**CONTAINMENT LINER TEST CHANNEL
AT
BEAVER VALLEY POWER STATION - UNIT NO. 1**

MARCH 1, 1979

**PREPARED BY
STONE & WEBSTER ENGINEERING CORPORATION
for
DUQUESNE LIGHT COMPANY**

NRC QUESTIONS AND RESPONSES

FIGURE 6
 DOME - SECTIONAL ELEVATION
 CONTAINMENT STRUCTURE
 BEAVER VALLEY POWER STATION - UNIT NO. 1
 DUQUESNE LIGHT COMPANY

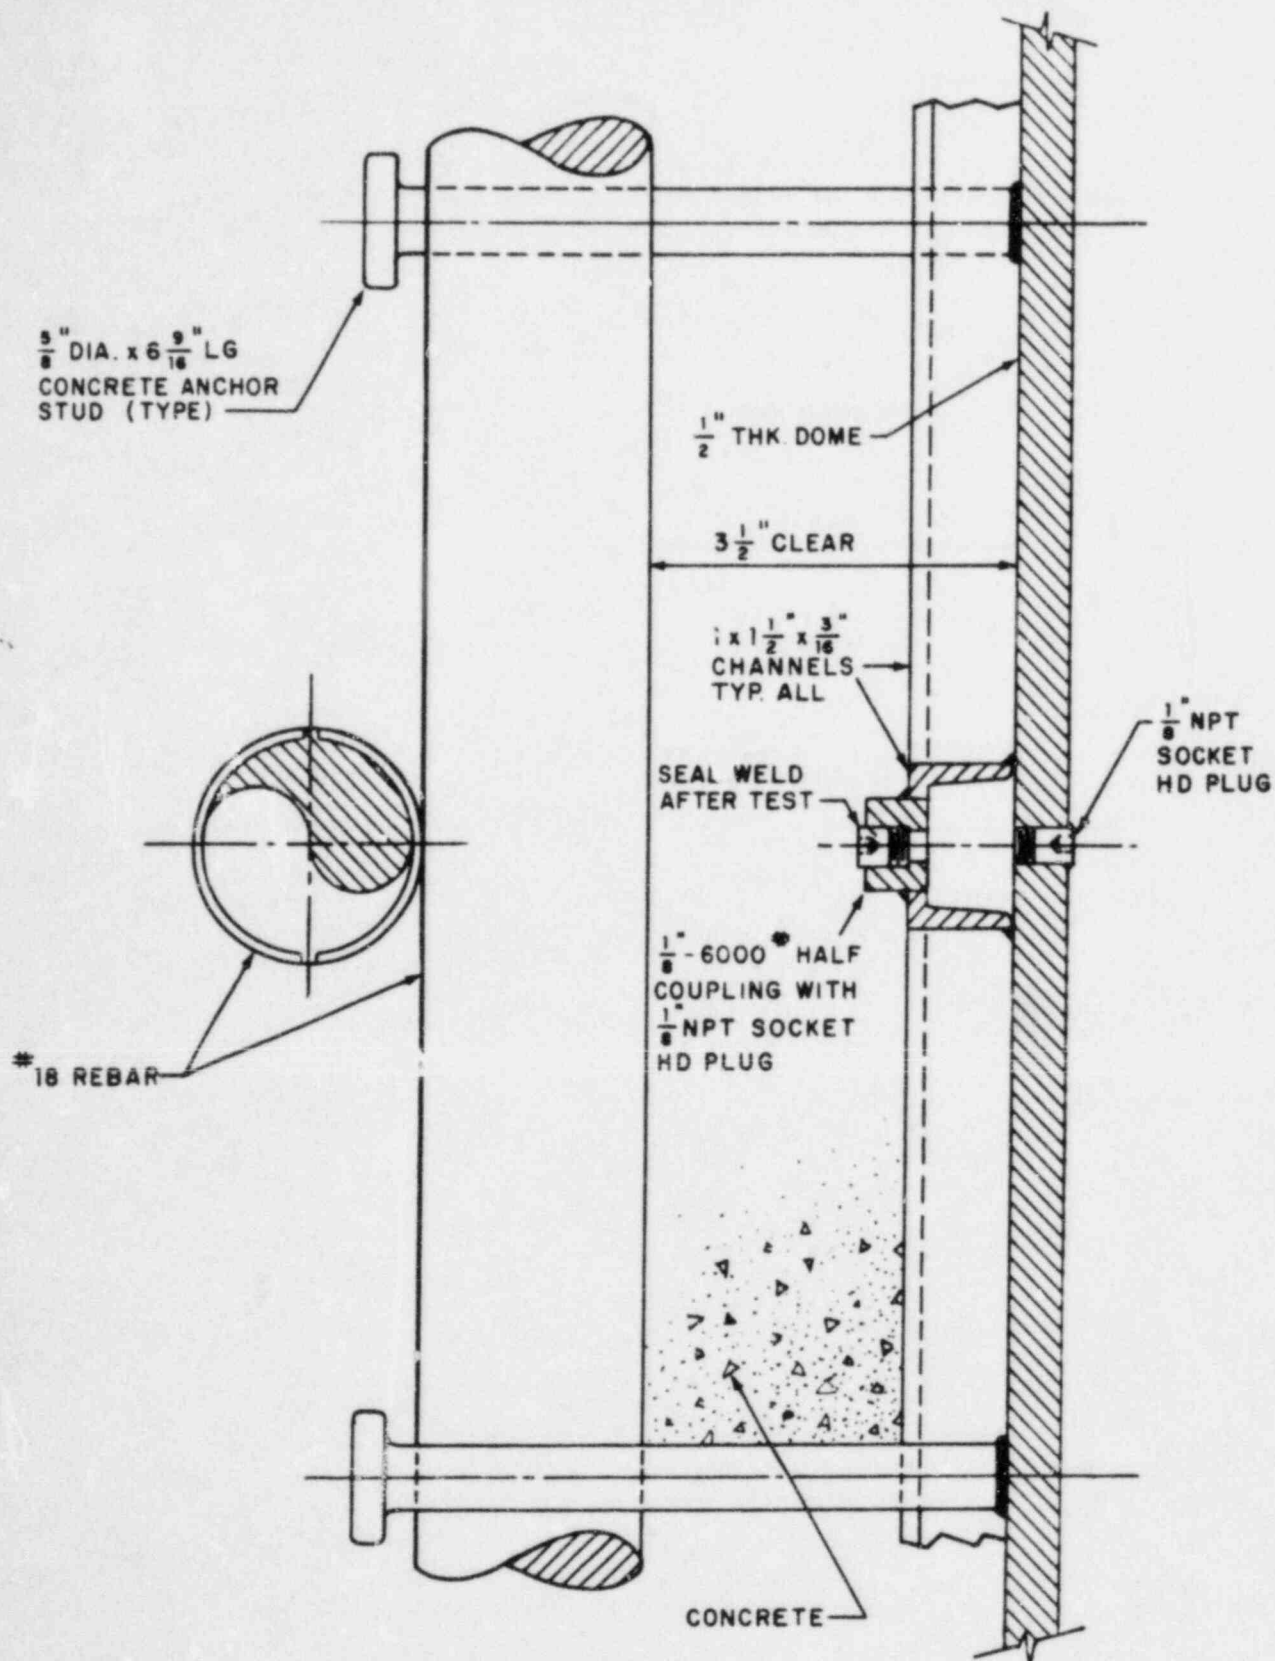
Provide an analysis which would demonstrate that the channels and channel welds will be capable of carrying the differential movement or expansion of the liner. Consider liner buckling or bulging due to Loss-of-Coolant Accident (LOCA) temperature and dynamic pressure effects and seismic loads. Provide a comparative analysis to demonstrate leak channels and their welds meet the requirements of the ASME Boiler and Pressure Vessel Code Section 3, Div. 2, as appropriate.

To further quantify the adequacy of the dome test channel welds to the containment dome liner (Figure 6) for shear forces which may exist between the liner and reinforced concrete structure, a horizontal ring of dome liner was isolated and the forces acting on this ring identified as indicated in Figure 8.3. The limits of the ring were chosen to be midway between adjacent horizontal dome test channels. Forces identified as acting on this ring segment are:

FIGURE 7
EFFECT OF pH ON CORROSION
OF MILD STEEL
CONTAINMENT STRUCTURE
BEAVER VALLEY POWER STATION-UNIT NO. 1
DUQUESNE LIGHT COMPANY

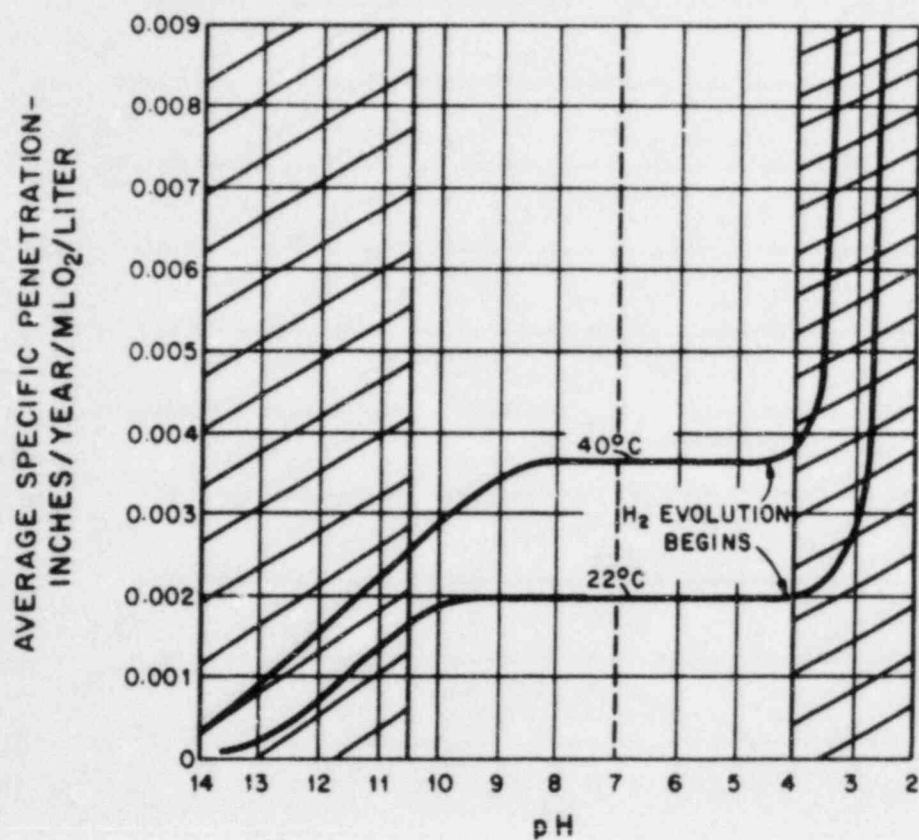
For plugged boxes with an undetected failed box weld or loose plug, provide analysis of condensation inside the box, chemical analysis of any condensed liquid, and corrosion rates of the liner, welds and channel boxes inside the boxes.

sodium hydroxide caustic spray) to 4.2 (boric acid in the safety injection accumulators at 2,200 ppm boron concentration) are, or may be present within the reactor containment. Figure 7, extracted from Uhlig's CORROSION HANDBOOK, Fifth Edition, is a plot of corrosion rates at various temperatures versus pH. The zone of interest, with a pH ranging from 4 to 10.5, has been highlighted. The curves demonstrate that, as pH is increased from 4, the corrosion rate will either remain constant or decrease with increasing pH.
